RE: **PETITION NO. 1221** - Windham Solar LLC petition for a declaratory ruling that no Certificate of Environmental Compatibility and Public Need is required for the proposed construction, maintenance and operation of two 1.0 Megawatt and one 1.5 Megawatt Solar Photovoltaic Electric Generating facilities located at 91 Plainfield Pike Road, Plainfield, Connecticut.

### **Petition No. 1221**

### **Windham Solar LLC**

**Staff Report**

**Revised/Updated Site Plan**

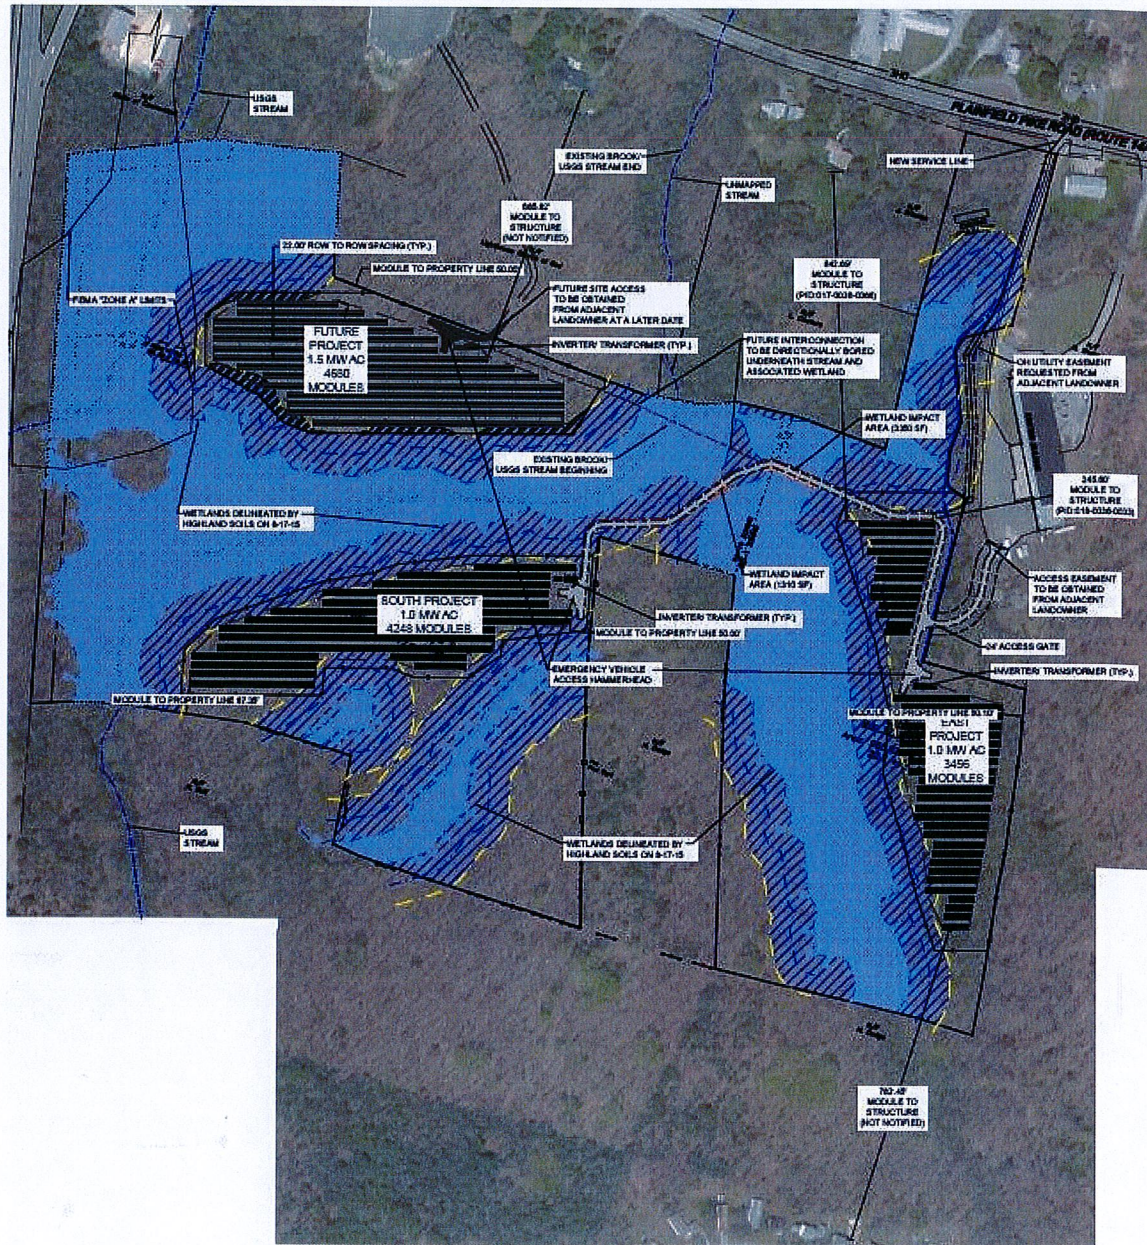
According to WS' most updated Site Plan received by the Council on May 2, 2016, the solar project has three portions on the same subject property: the Future Project; the South Project; and the East Project. (The most current updated site plan is attached.) The Future Project is 1.5 MW AC and approximately 4,680 modules and located in the northwestern portion of the subject property. The South Project is 1.0 MW AC and approximately 4,248 modules and located in the southwestern portion of the property. The East Project is 1.0 MW AC and approximately 3,456 modules and located in the southeastern portion of the property. Each of the three projects would have their own inverter and transformer pads.

The Petitioner would acquire an access easement from the auto body property to the east. This would allow the Petitioner to have direct access to the East Project. Then the proposed access would run to the north and then continue westward to the South Project. Since the original filing, a brook or stream was discovered just east of the Future Project. This leaves the Future Project isolated and difficult to access from the subject property. WS has not secured an easement via an abutting property on Route 14A which would eliminate a brook crossing and associated impacts. In addition, Eversource, the local electrical distribution utility, has confirmed that only 2 MW of interconnection capacity is available. Thus, the Petitioner continues to seek Council approval of the Future Project, South Project, and the East Project, but is willing to limit its construction at this time via the D&M Plan. In other words, the first D&M Plan would only include the East and South Projects. Should off-site access be secured to the north in the future, staff suggests that the Petitioner file a separate D&M Plan for the Future Project and include the details of its new access to the north.

The mapped wetlands comprise approximately one-fourth of the site. Wetlands are located on the eastern portion of the subject property and surround the East Project to the west and north. Wetlands also surround the South Project and North Project. While the solar arrays and associated equipment would not have direct wetland impacts, proposed on-site access that would connect the South Project to the East Project would result in direct wetland impacts of approximately 4,660 square feet. Council staff had inquired about the possibility of shifting the access to the South Project slightly north to avoid wetlands, but was informed by the Petitioner that the brook would prevent such scenario. Notwithstanding, the Petitioner has made some adjustments to the access to reduce the wetland impact area from 6,015 square feet to about 4,660 square feet. The wetland impacts are anticipated to be eligible for a Category I permit from the U.S. Army Corps of Engineers. WS has provided a copy of its Category I permit form dated June 21, 2016.

The Future Project would encroach on the VPE of Vernal Pool 1 by roughly 20 feet. However, the Future Project would be located within the CTH of Vernal Pool 1. The Future Project has a footprint area of about 5.6 acres. Thus, the Future project would result in a development area of 14 percent of the CTH. Accordingly, the Future Project plus the South Project would cumulatively result in over 27 percent development within the CTH. Cumulatively, this would not comply with the 2002 BDPs because it would exceed 25 percent. Council staff notes that, if approved, any D&M Plan that includes the Future Project should include a Vernal Pool Habitat Impact Mitigation Plan.

- The Petitioner shall prepare a Development and Management Plan (D&M) for this site in compliance with Sections 16-50j-60 through 16-50j-62 of the Regulations of Connecticut State Agencies. The D&M Plan shall be served on the Town of Plainfield for comment and submitted to and approved by the Council prior to the commencement of facility construction and shall include:
  - a) A final site plan for the East Project and the South Project including, but not limited to, the electrical interconnection design, fence design and access;
  - b) A final site plan for the Future Project including, but not limited to, the electrical interconnection design, fence design and access;
  - c) Vernal Pool Habitat Impact Mitigation Plan for the Future Project;
  - d) Erosion and sedimentation control plan consistent with the *2002 Connecticut Guidelines for Erosion and Sedimentation Control*;
